RFP # 2024-0305.02

**RFP Addendum: Questions and Answers
Temple Museum Renovations and Improvements Phase I**

REVISIONS		CITY OF TEMPLE, GEORGIA	
		TEMPLE MUSEUM	
		PROPOSED SITE PLAN	
DRAWN	CHECKED	SCALE: AS SHOWN	DATE: DECEMBER 2023
SR/SPS	GJA		
		ATLANTA AUGUSTA ST. SIMONS ISLAND	SHEET 1 OF 4

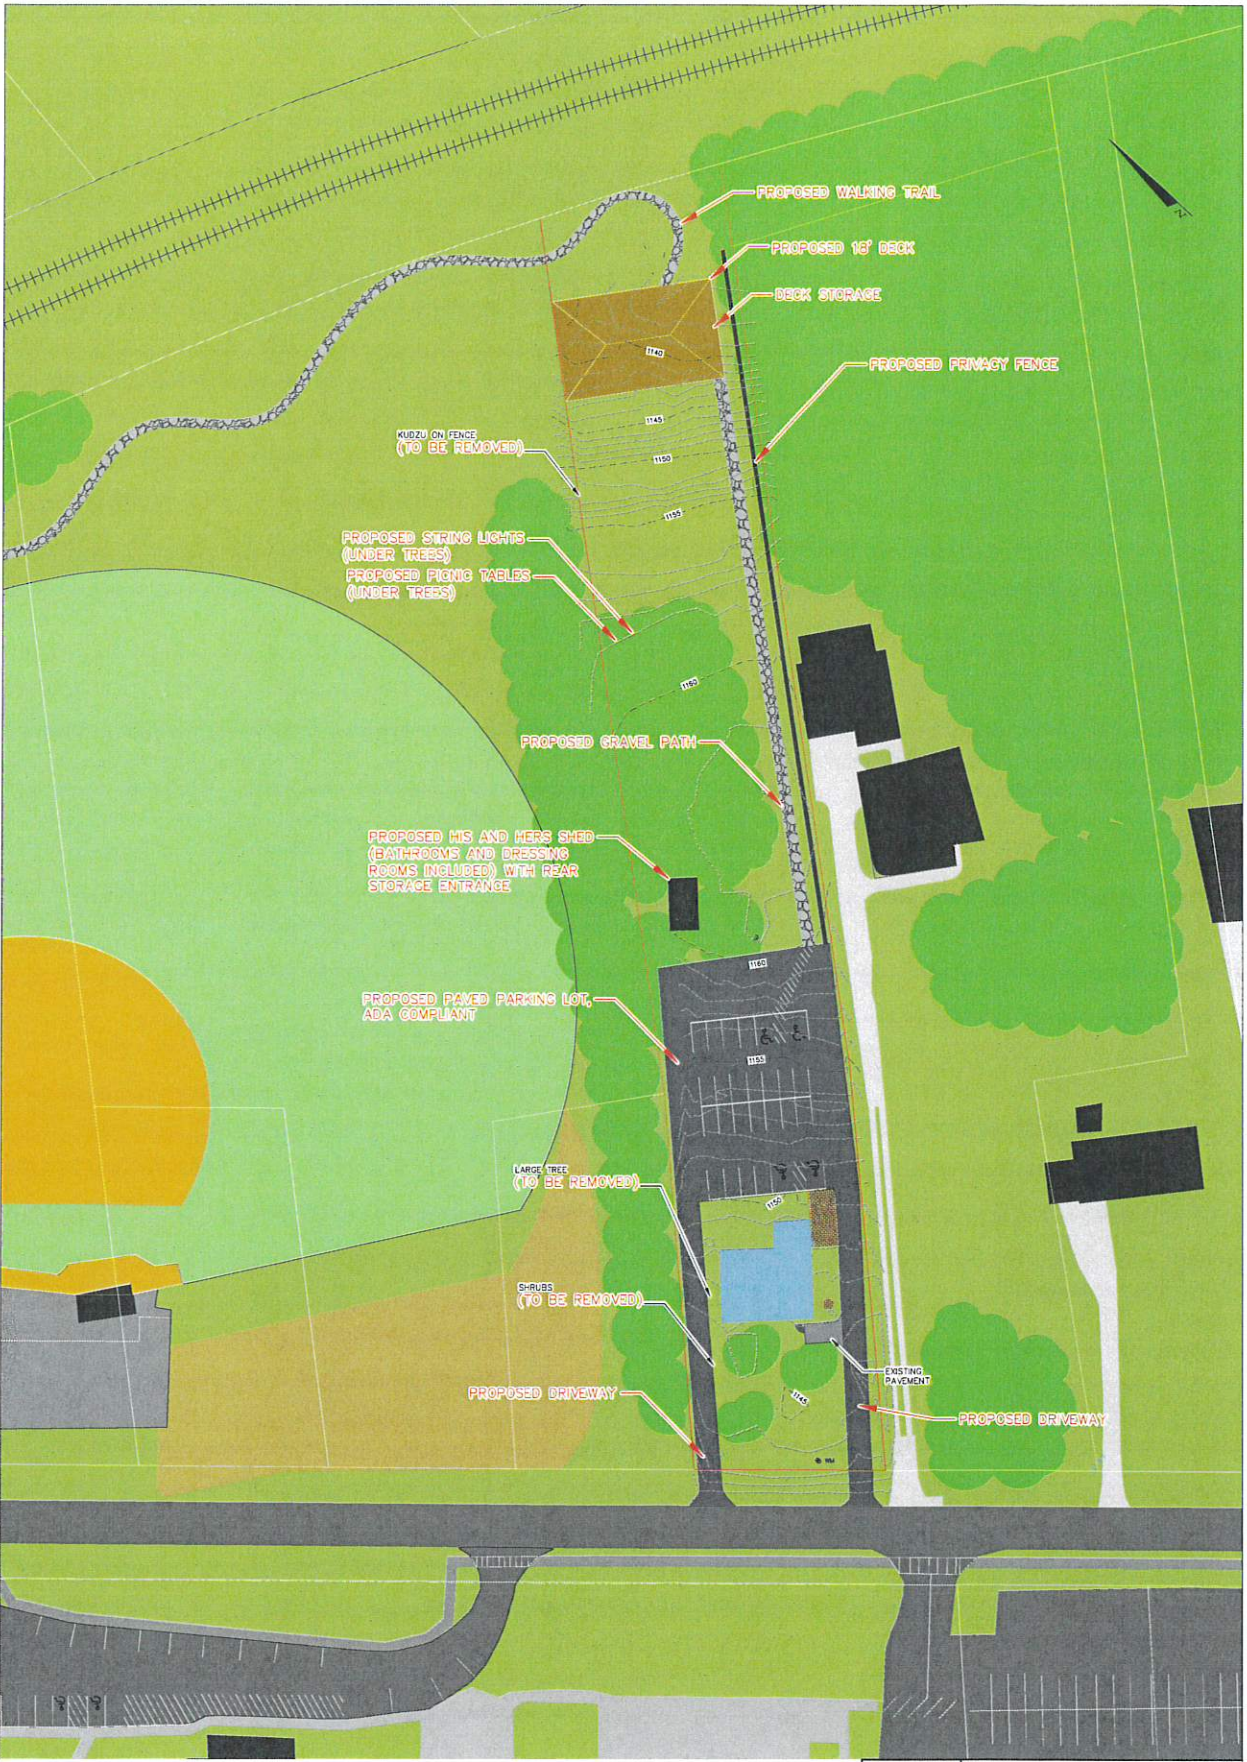
Will there be official drawings and specifications released for use on this project bid?
The original site drawing is attached.
